Value Engineering Study
WWTP #2 Improvements
Coos Bay, OR

FINAL VALUE ENGINEERING STUDY REPORT

WWTP #2 IMPROVEMENTS

Coos Bay, OR

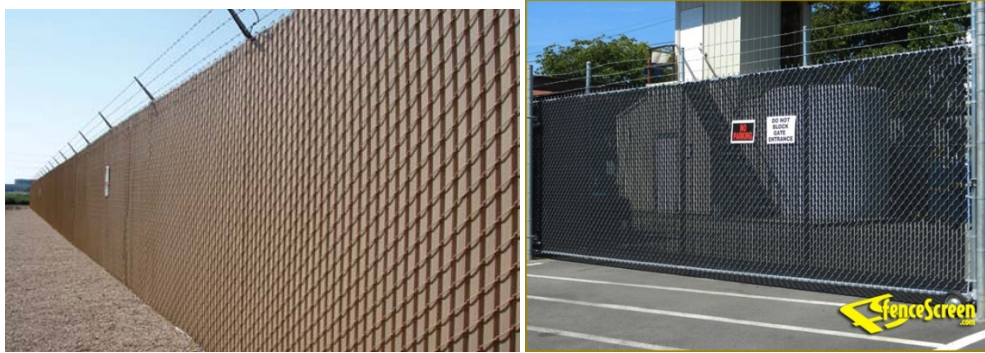
The alternative is feasible. Proposed chain link fence with barbed wire will likely be unacceptable to the City's elected officials and the community due to the prominent location of the treatment plant site along South Empire Boulevard and its proximity to a residential neighborhood.
